RE: The Domain Rezoning – C14-2010-0087 – Approximately 50 acres Located at 11701, 11733 N Mopac Expressway; 11400, 11500 Domain Drive; 3311 Rogers Road; 3409 Esperanza Crossing; 11600 Century Oaks Ter; (the "Property"); Proposed Rezoning from MI-PDA Zoning to MI-PDA Zoning

## ZONING CHANGE REVIEW SHEET

CASE: C14-2010-0087 (The Domain Rezoning-Simon) P.C. DATE: August 10, 2010

- TO: Sherri Sirwaitis, Planner Senior, Planning & Development Review Department
- FROM: Annick Beaudet, AICP, Program Consultant, Public Works Department
- DATE: July 15, 2010
- SUBJECT: C14-2010-0087 (Simon)

# C14-2010-0036

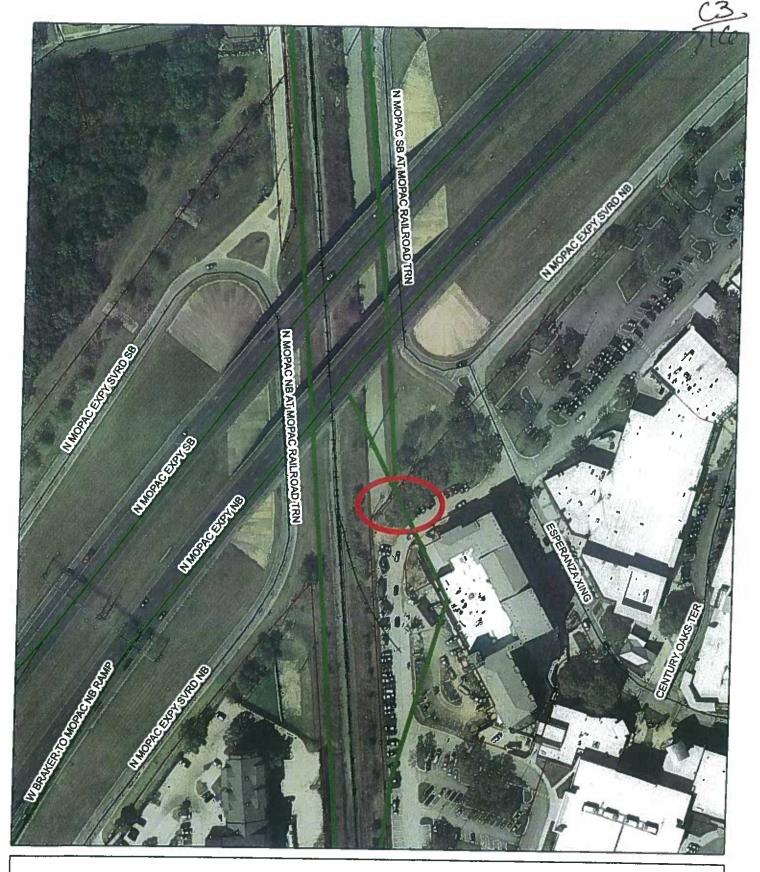
The City of Austin Bicycle Program recommends the applicant provide bicycle access and internal continuity for portion of Bicycle Route Segment #905.04 – Kramer LN from MOPAC EXPY N to Domain DR by providing and formalizing the <u>pedestrian/bicycle</u> entrance as identified on the attached bicycle network map including construction of a connecting minimum 12 foot paved path to the street with associated curb cut.

Additionally, the Bicycle Program recommends the installation of shared lane markings (sharrows) as depicted below along the following roadways:

- Esperanza Crossing from Oaks Terrace to Domain Dr.
- Domain Dr. from Esperanza Crossing to Kramer Ln.
- Domain Dr. from Domain Blvd. to Esperanza Crossing, west side of the street only (note: Simon does not own or have control over the east side of the street).

The shared use markings (sharrows) shall be installed in compliance with the following standards:

- •
- Angled and head in parking prohibited on either side of roads with required sharrows.
- For roadways with the outermost lane being less than 14 feet wide, the tip of the shared lane chevron shall be in the middle of the lane; and

For roadways with the outermost lane being 14 feet or wider, the tip of the shared lane chevron shall be 4 feet from the face of curb.

The formalized pedestrian/bicycle entrance, connecting path to the street, and shared lane markings (sharrows) shall be installed within one year of this agreement.
